City of Portland, Maine – Building or Use Permit Application 389 Congress Street, 04101, Tel: (207) 874-8703, FAX: 874-

LAND USE - ZONING REPORT

REASON FOR PERMIT: Change of use from illegal 2-family to 1 family

BUILDING PERMIT REPORT

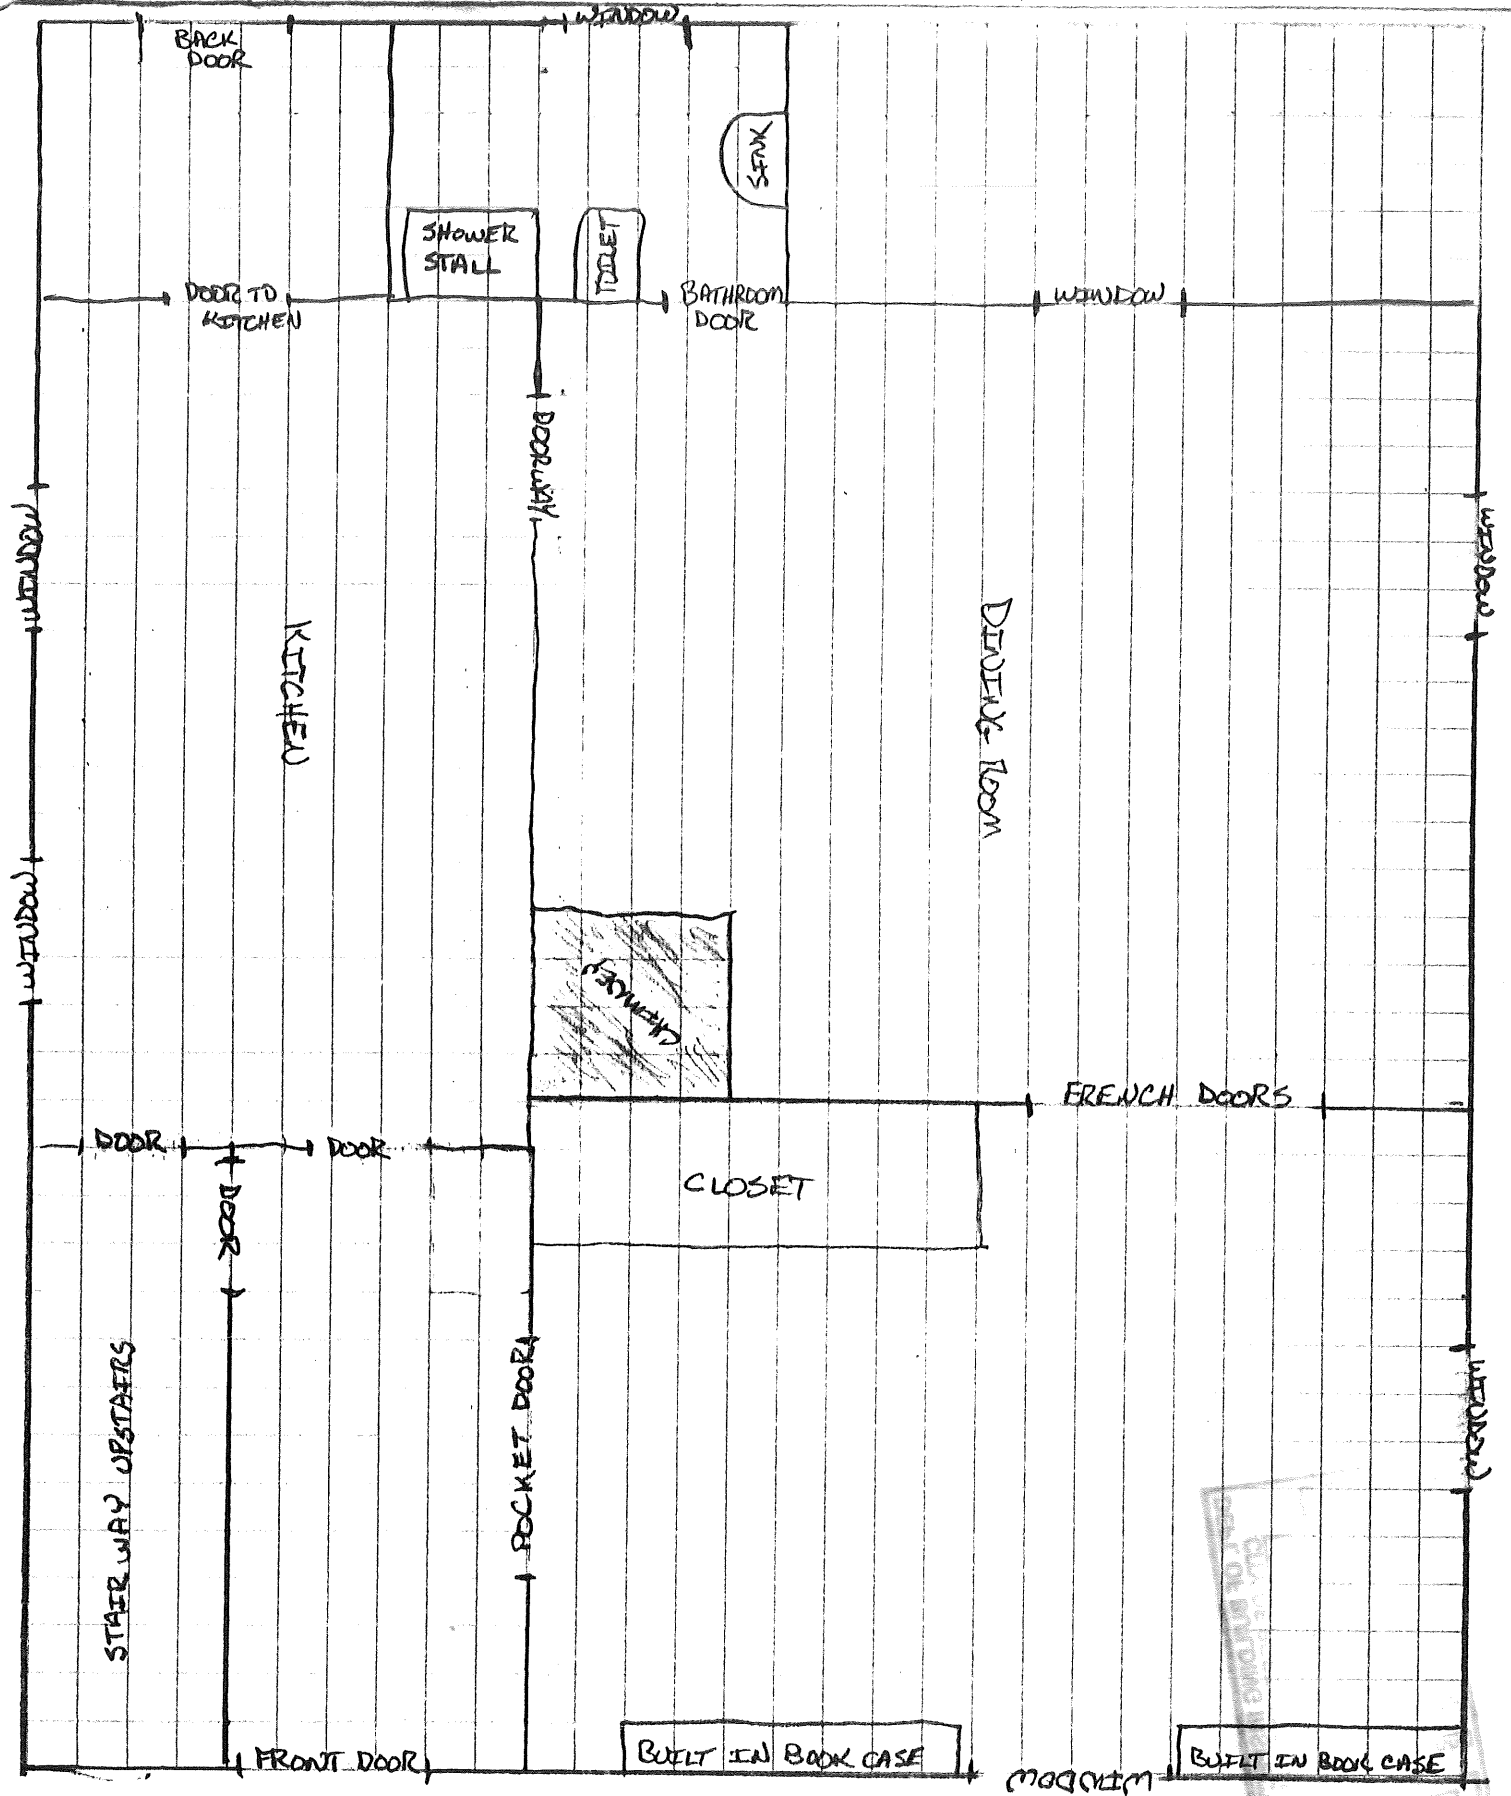
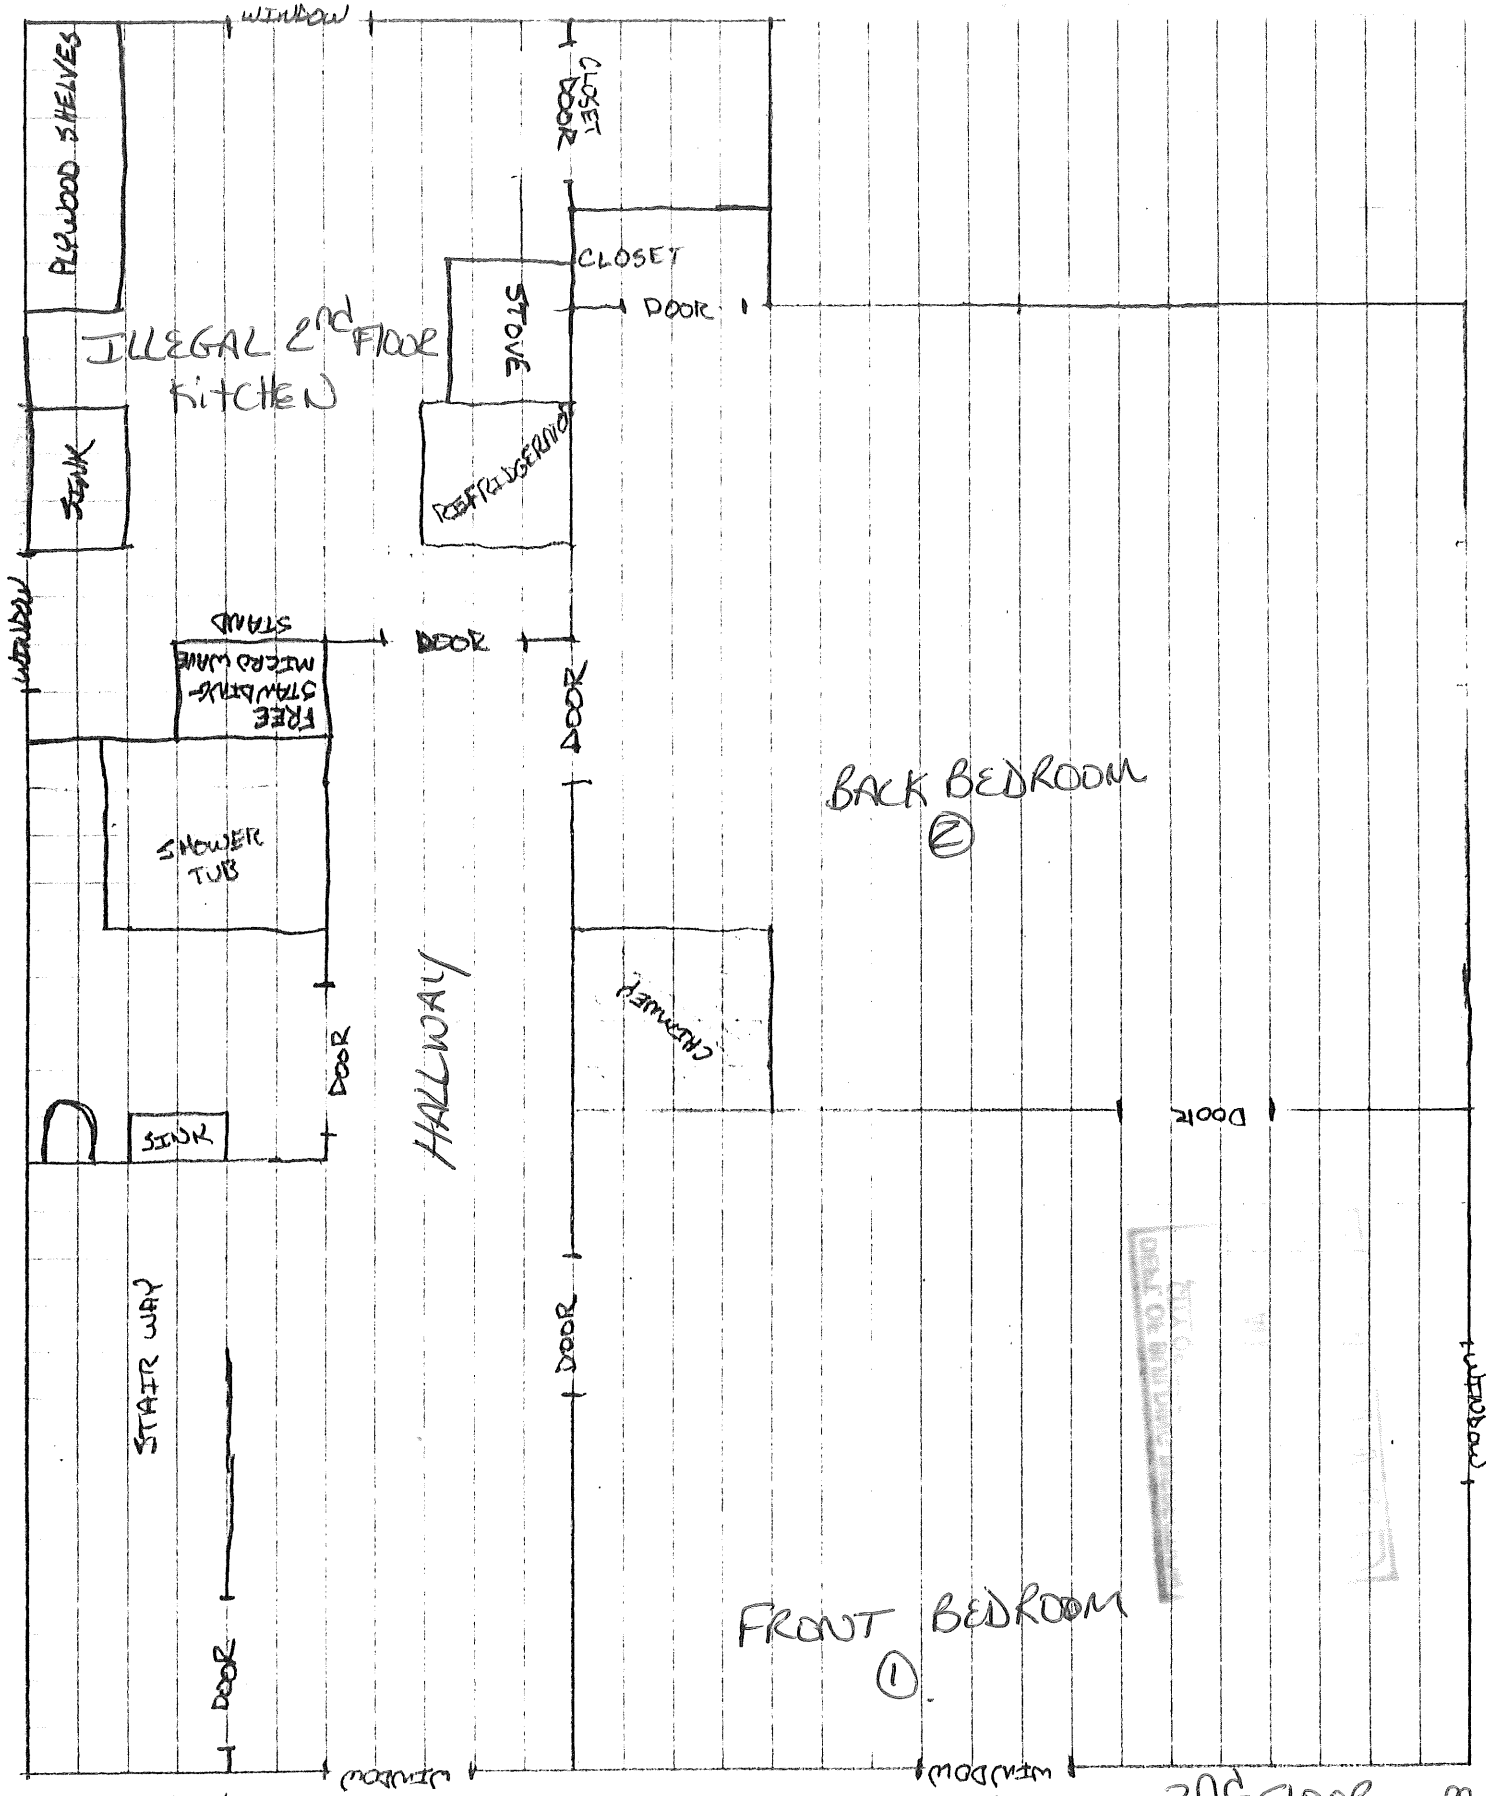
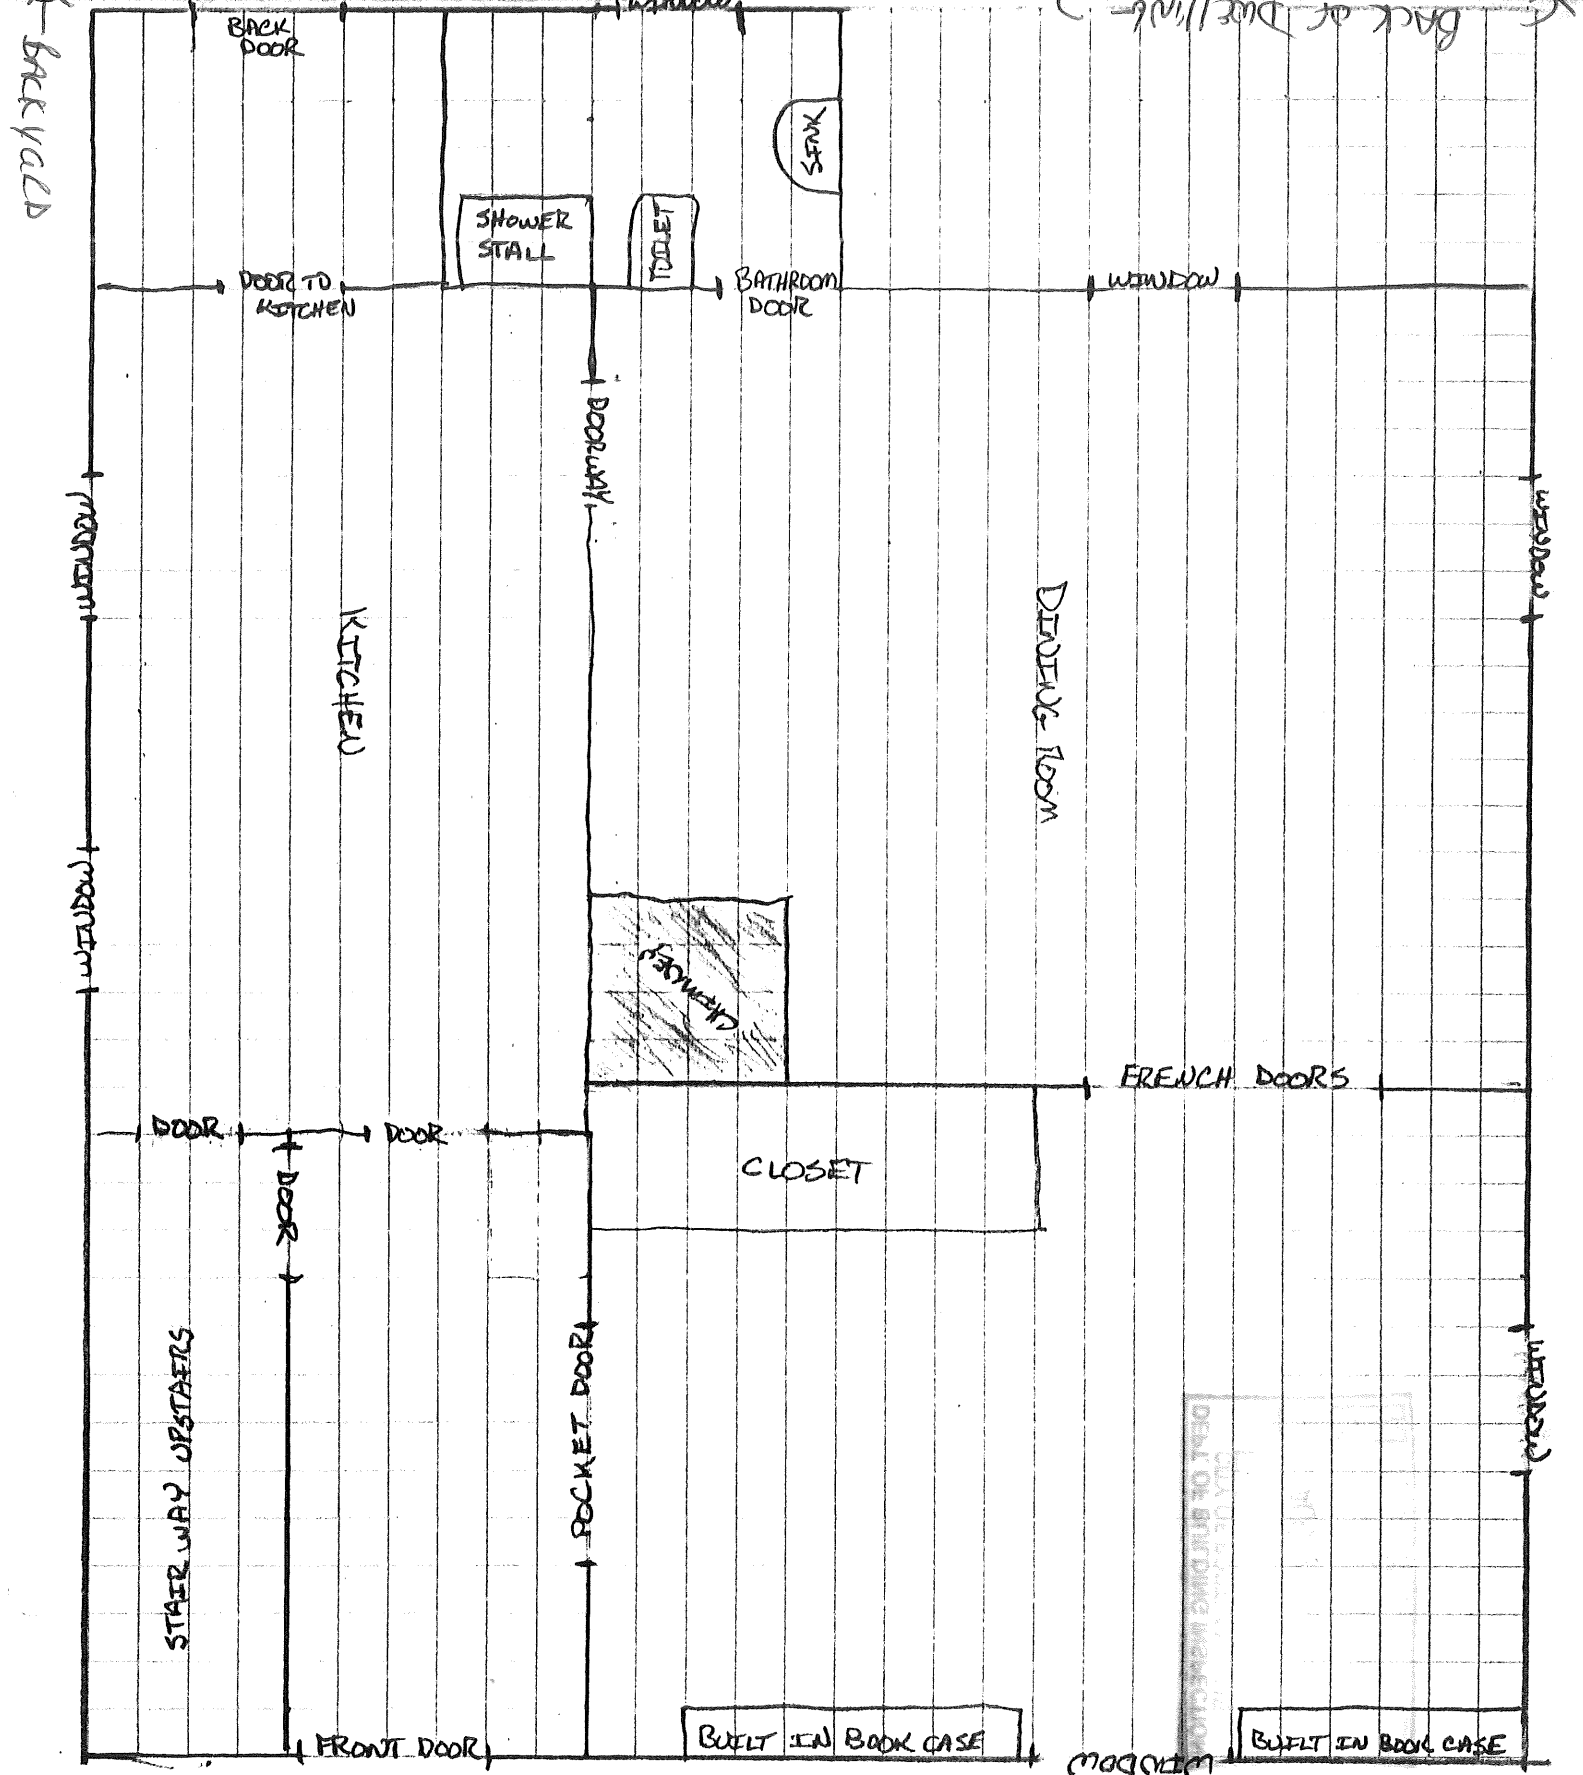
7. Separate permits shall be required for any signage.
8. Separate permits shall be required for future decks and/or garage.
9. Other requirements of condition The illegal kitchen on the 2nd floor shall be removed in its entirety.

I hope that these copies will be sufficient. There is a layout of the dwelling as how it appears at this place in time and a layout as to how it shall appear after the second story kitchen is removed. It should resemble the layout the building inspector reported back to you on May 6, 1997. As you can see from the layout that there is only one front entry and one back entry.

When I put this dwelling under contract, the contract stated that the dwelling is a one family dwelling. I intend to keep the dwelling a one family. The second story kitchen located in the third bedroom will be returned to a bedroom within two months from closing. The sink shall be removed within two days after closing.
